FOURSQUARE AT STERLING RANCH EAST FILING NO. 1 GRADING AND EROSION CONTROL PLAN			
DESIGNED BY	DLG	SCALE	DATE 11-30-22
DRAWN BY	DLG	(H) 1" =	SHEET 2 OF 27
CHECKED BY	(V) 1" =	JOB NO.	1183.23

FOURSQUARE AT STERLING RANCH EAST
FILING NO. 1
GRADING AND EROSION CONTROL PLAN

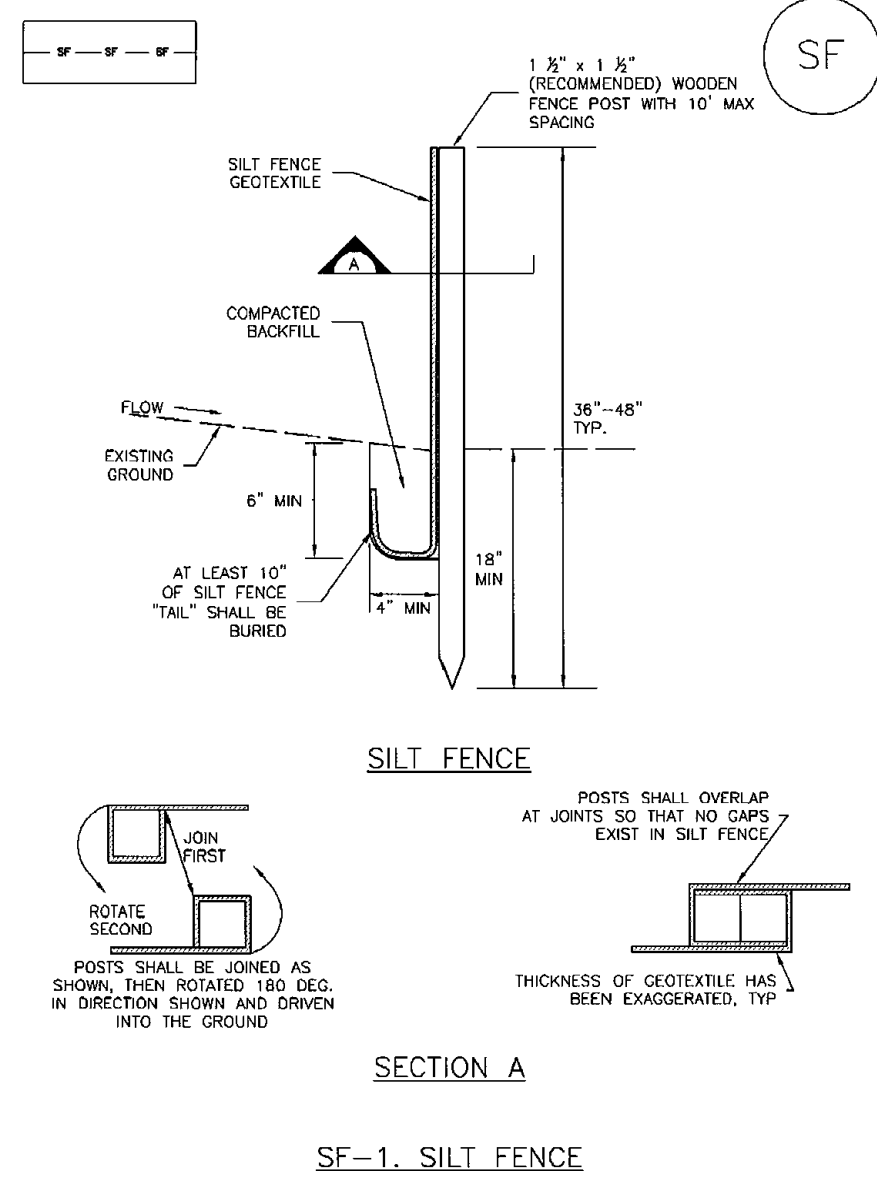
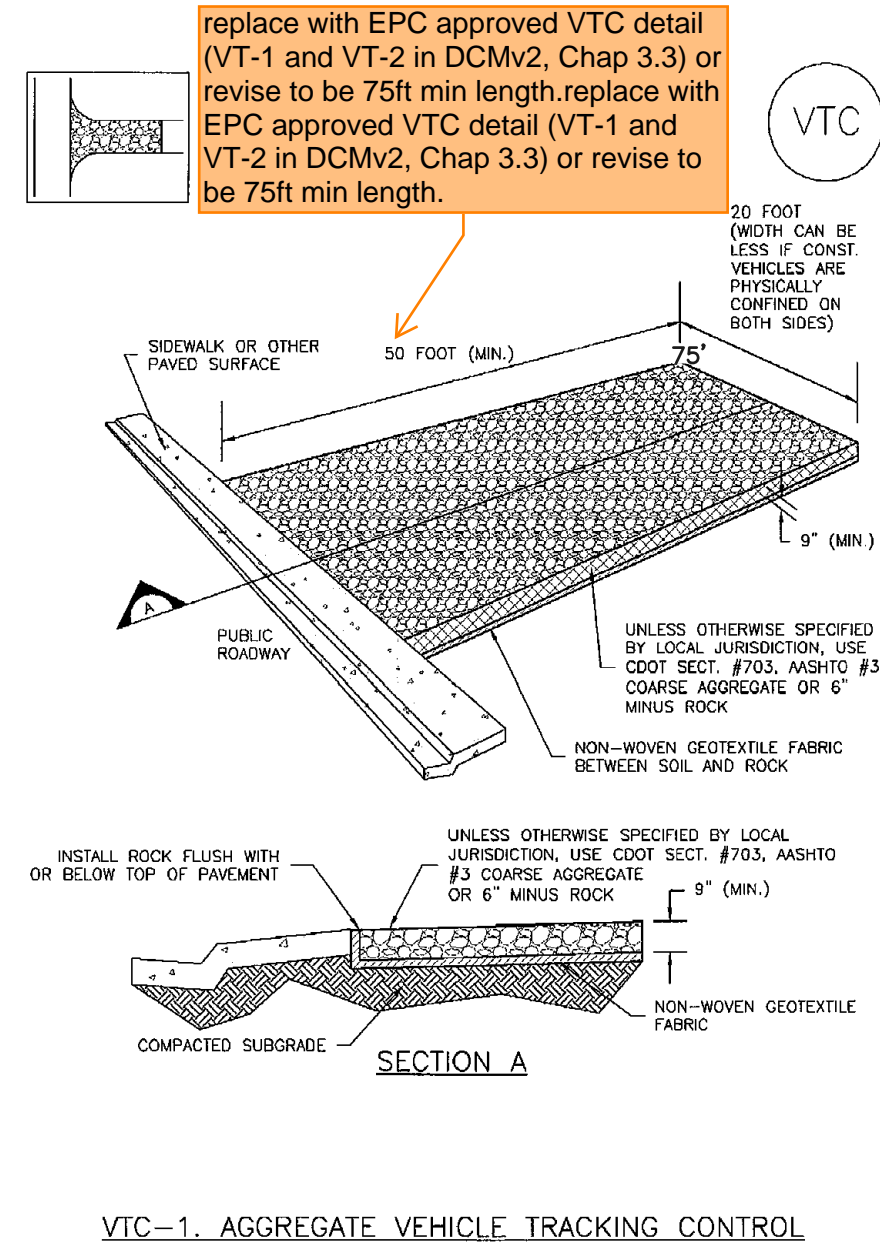
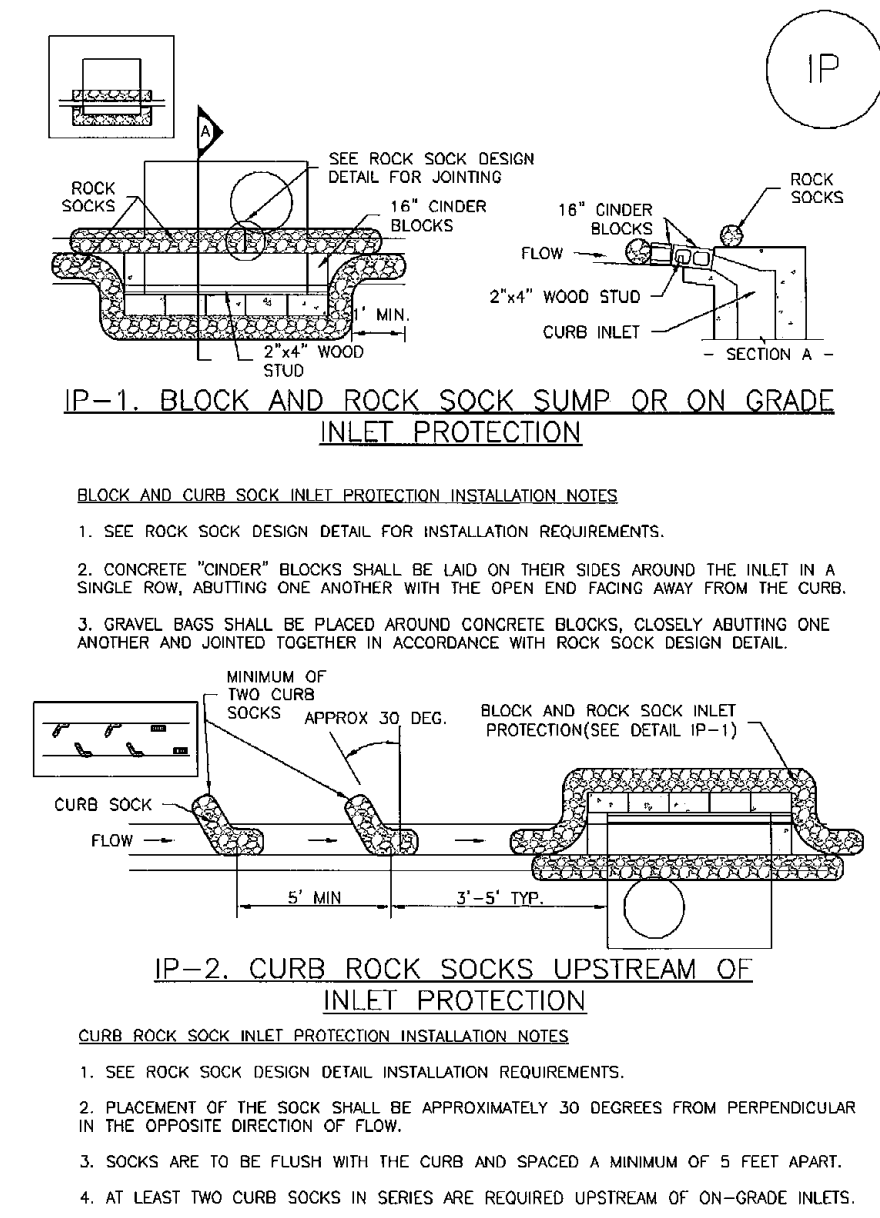
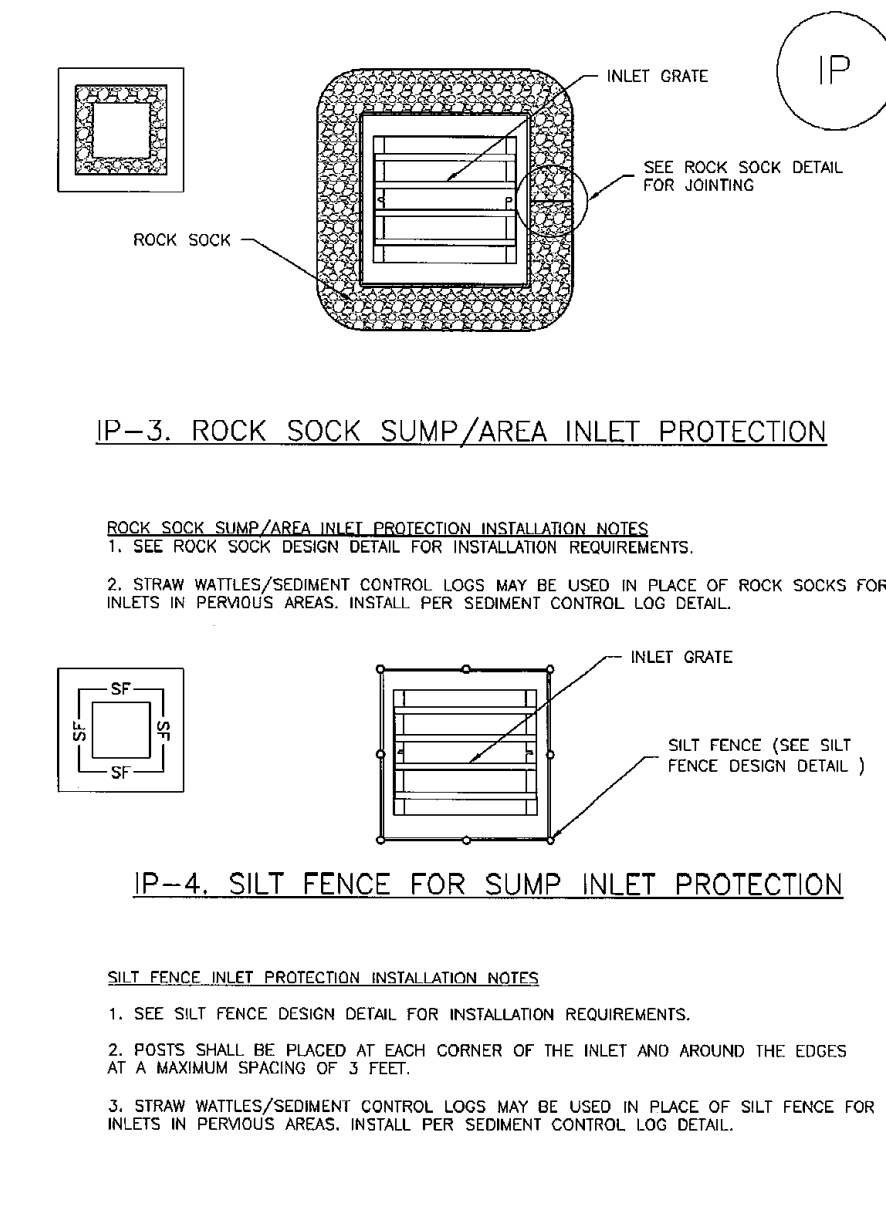
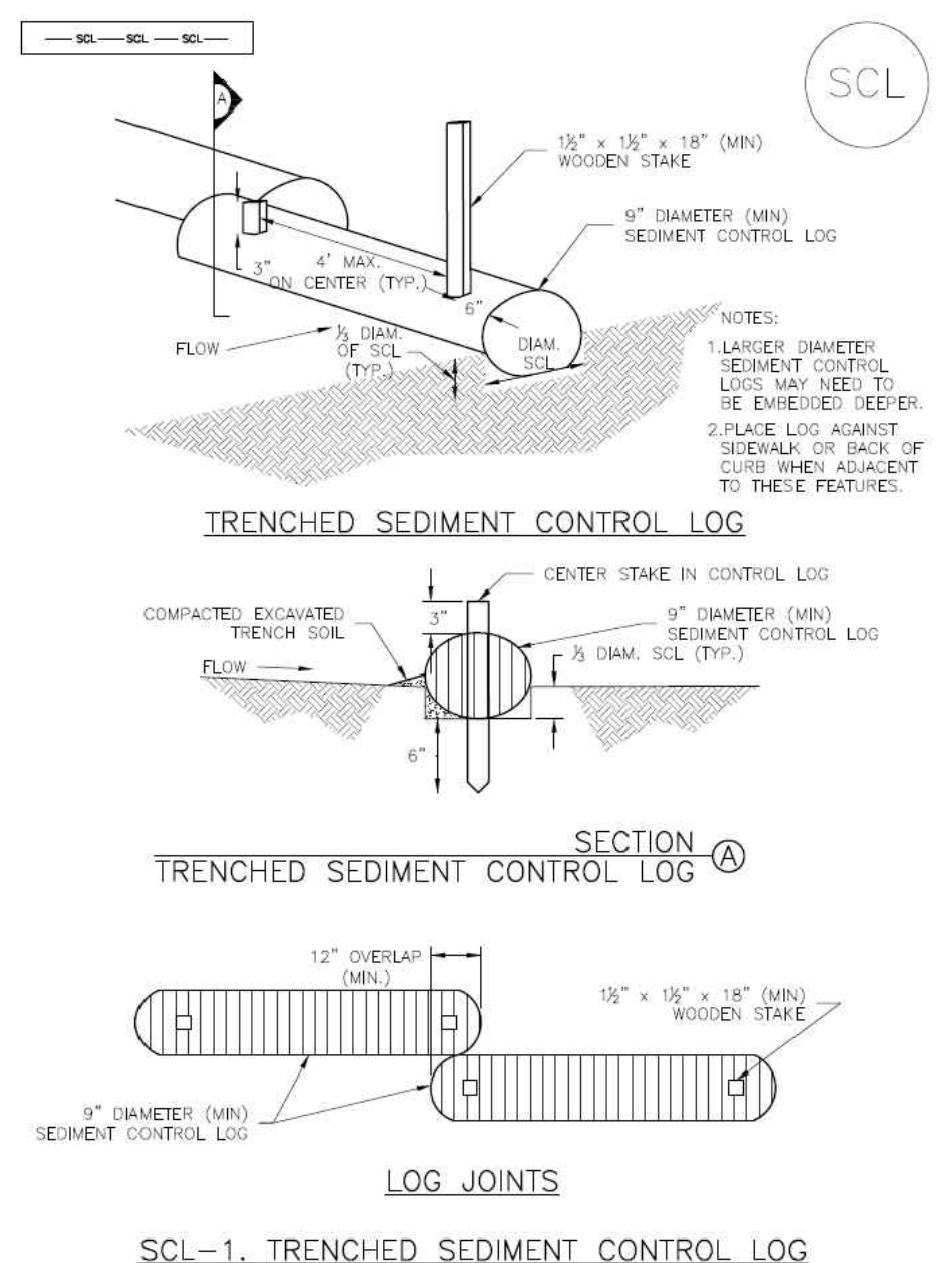
Item Z. Include details for the following BMP's. Examples of acceptable details for each are provided:

BMP	Detail # and Source		
	DCM (Vol 2: Chap 3.3)	MHFD (USDCM Vol 3: Chap 7)	COS - Stormwater Construction Manual (App E)
Mulching	MU-1	EC-4	X
Rolled Erosion Control Products	ECB-1, ECB-2	EC-6	X
Seeding	TS-1	EC-2	X
Sediment Basin	SB-1, SB-2	SC-7	X
Stabilized Staging Area		SM-6	
Stockpile Protection & Mgmt		MM-2	X

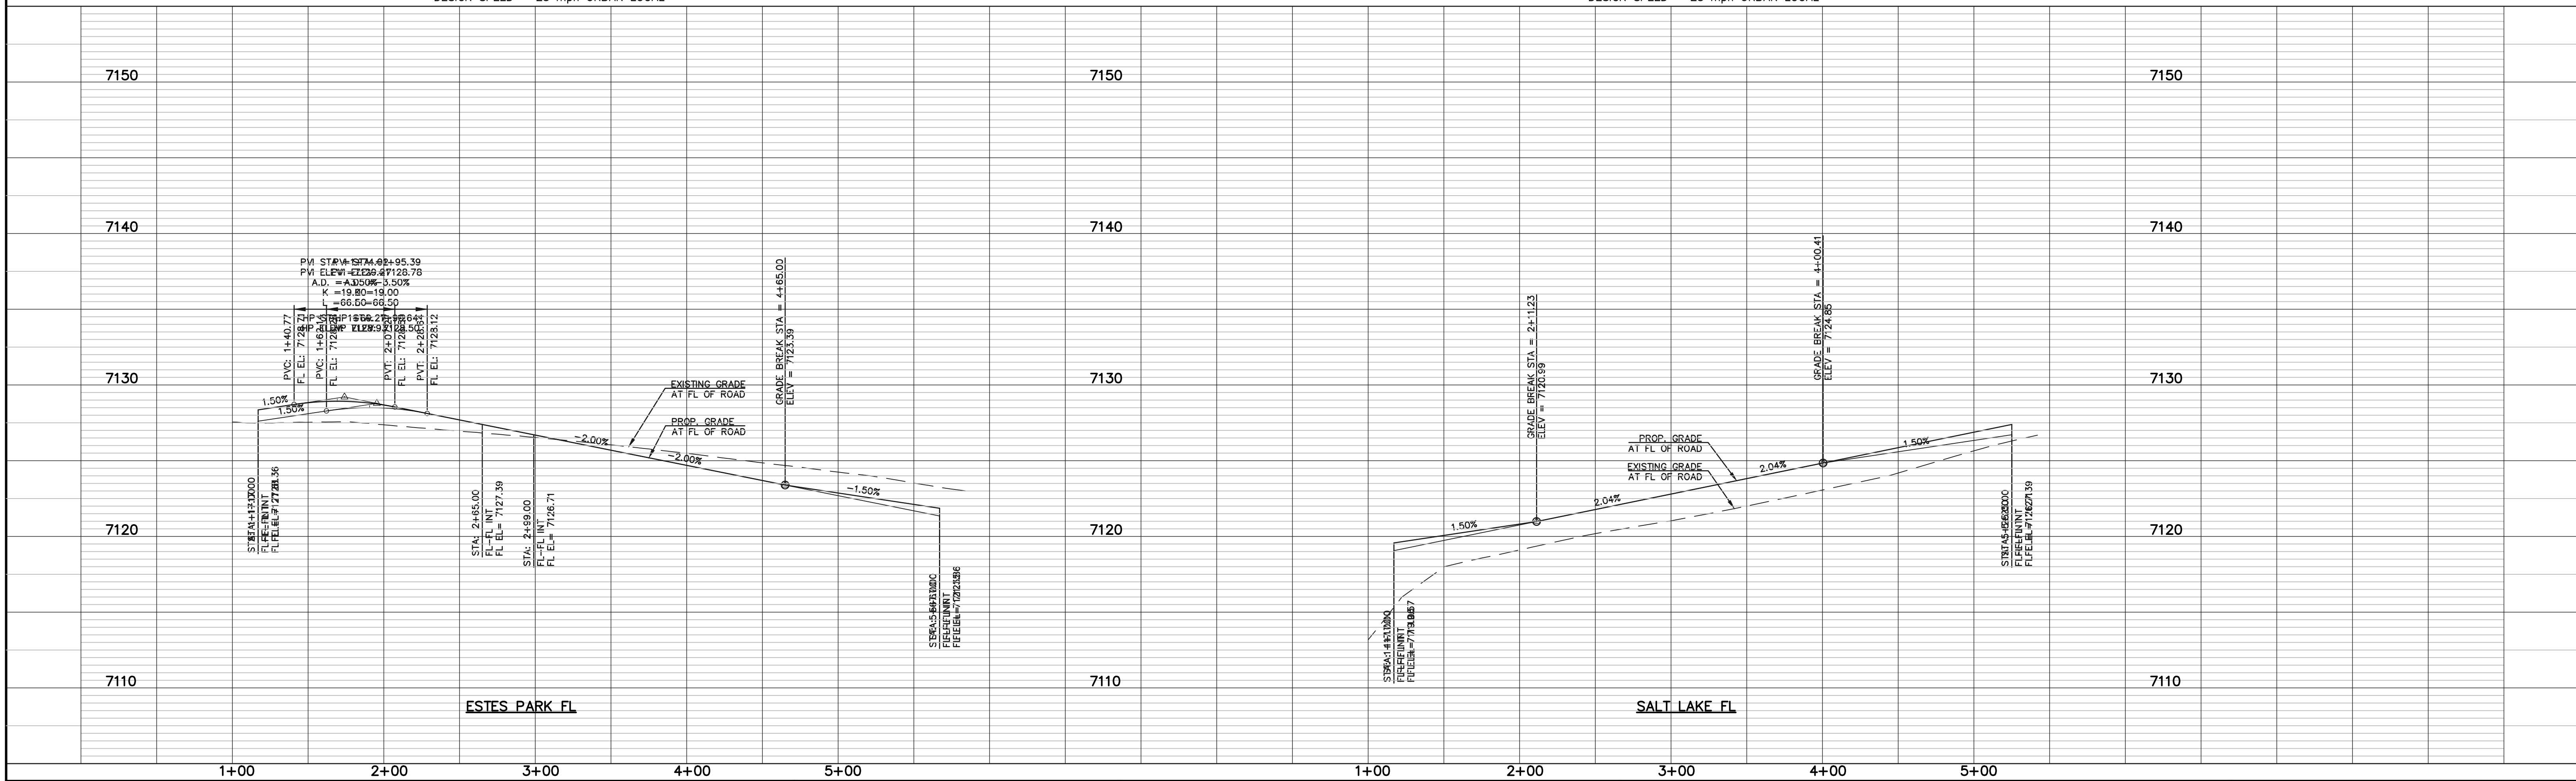
Delete this statement on all sheets

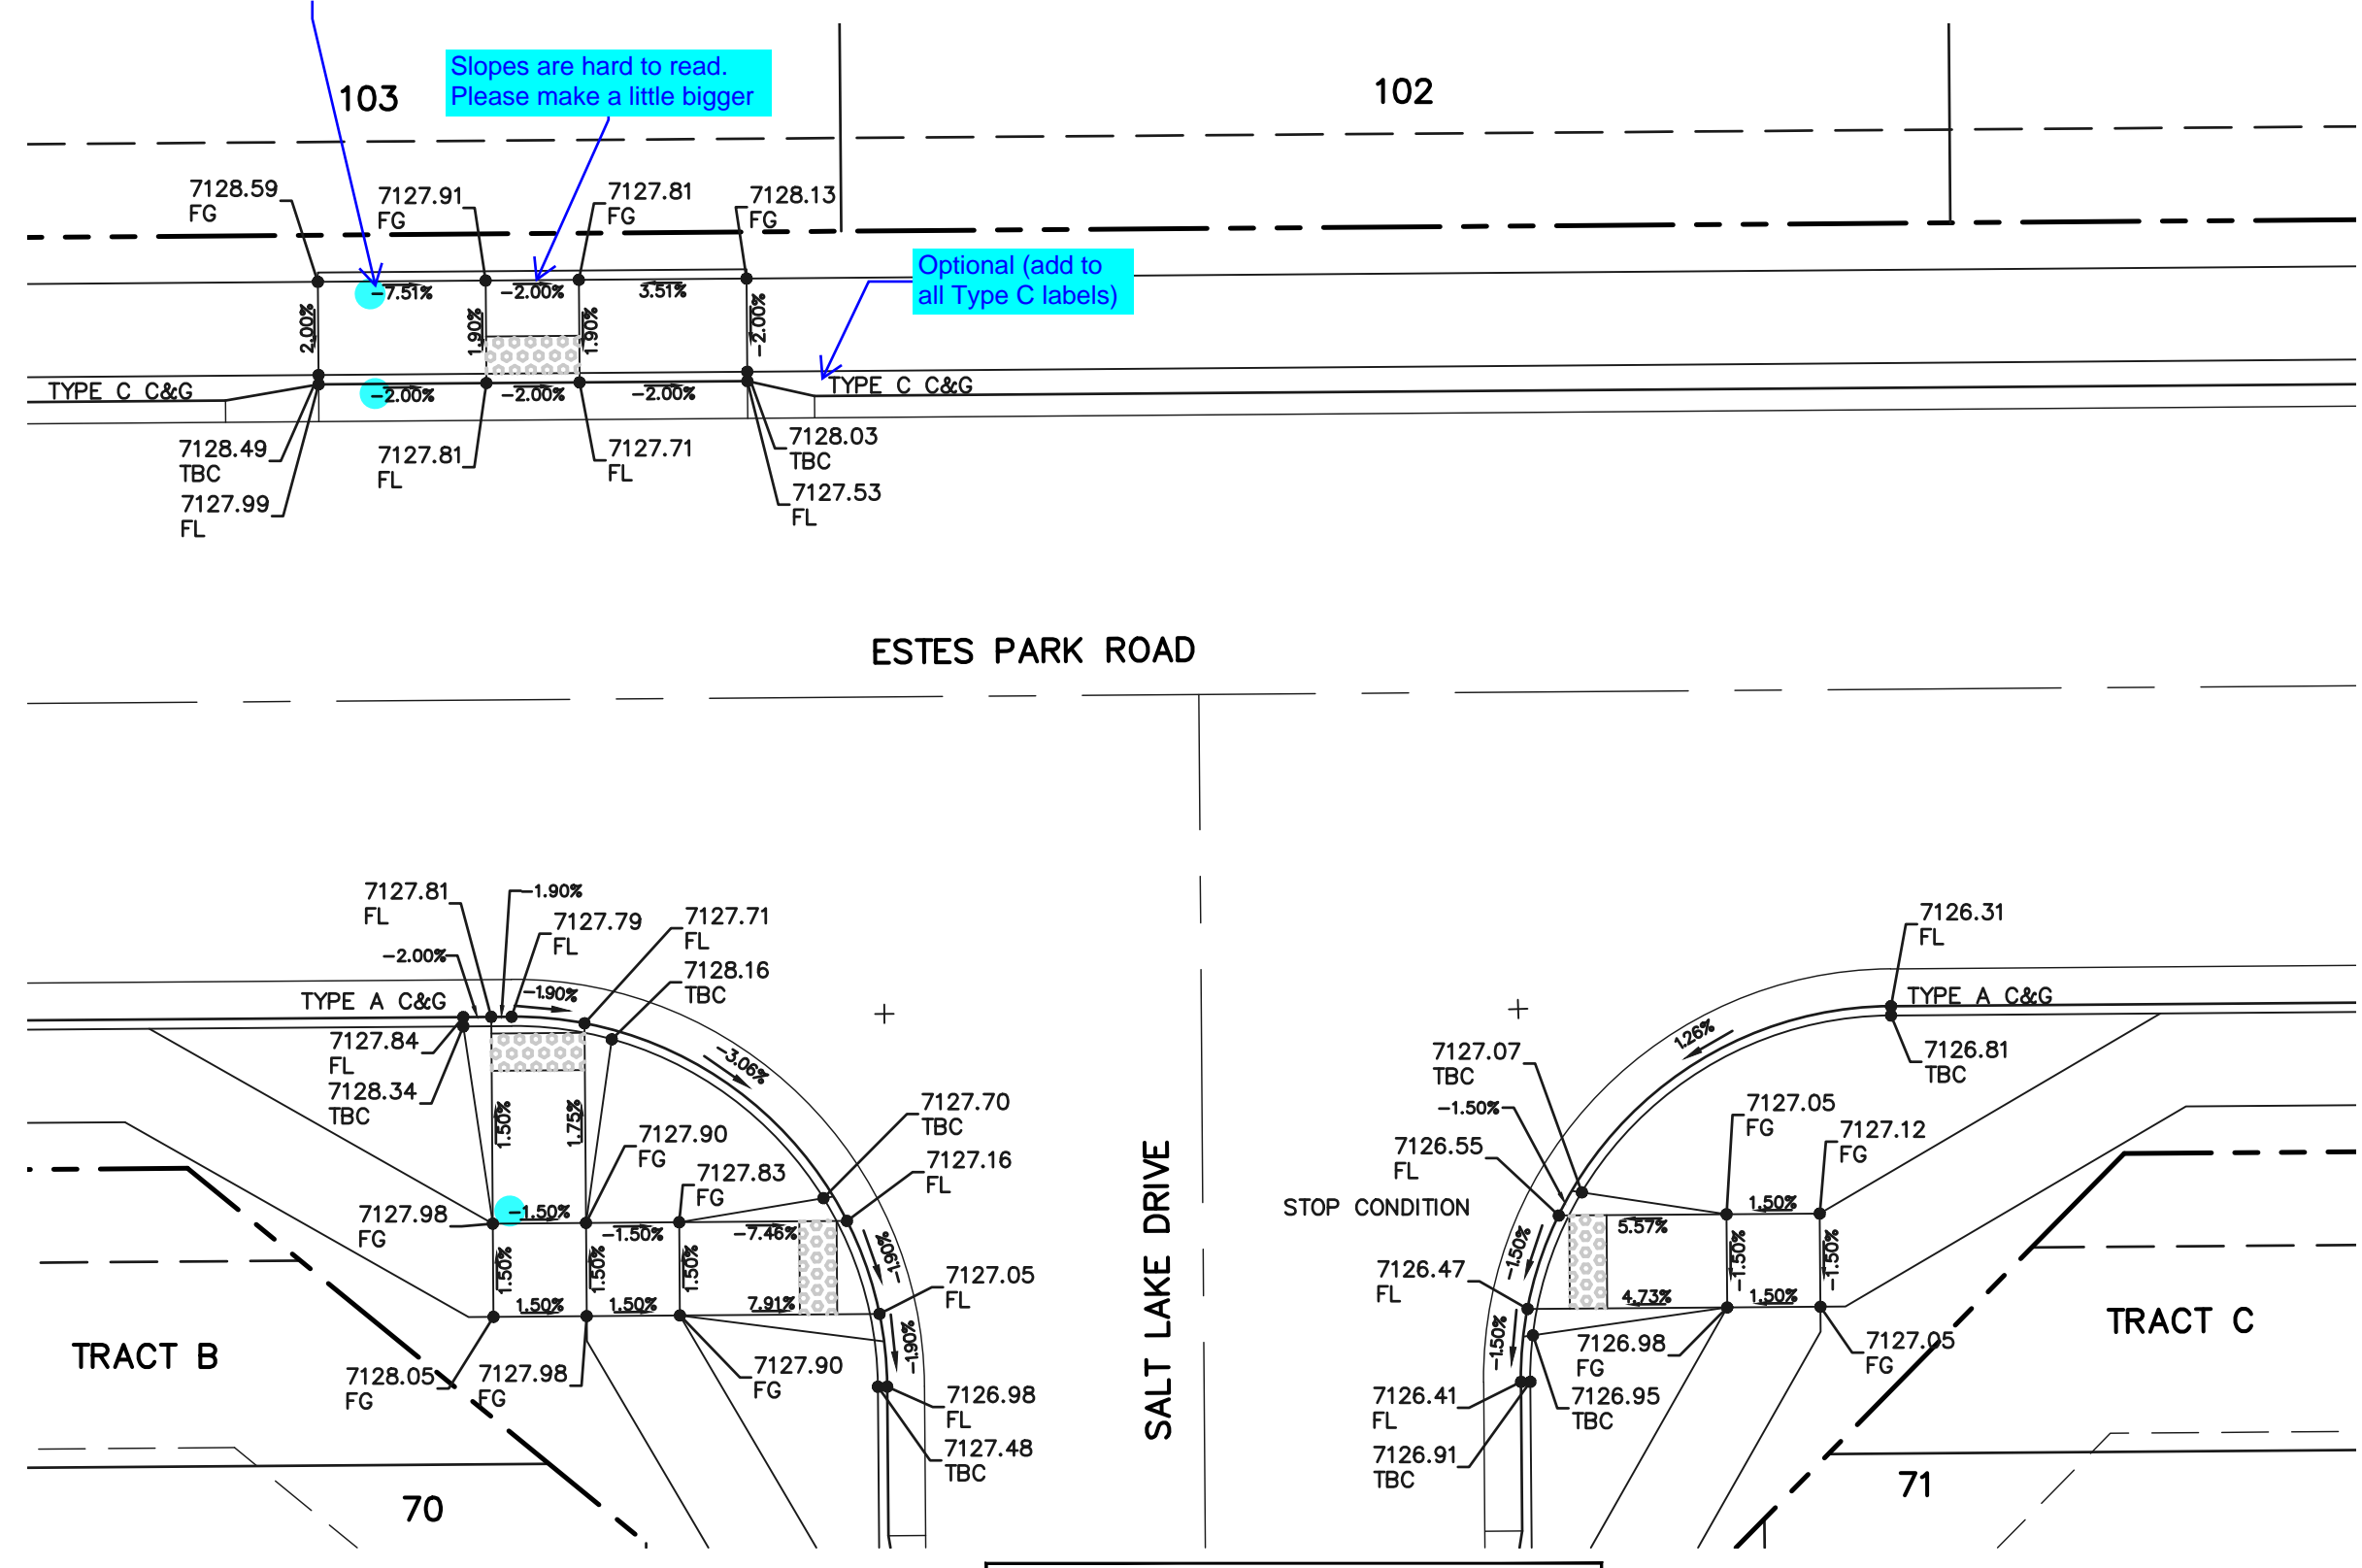
label slope directions and positive/negative consistently (removal of negatives preferred)
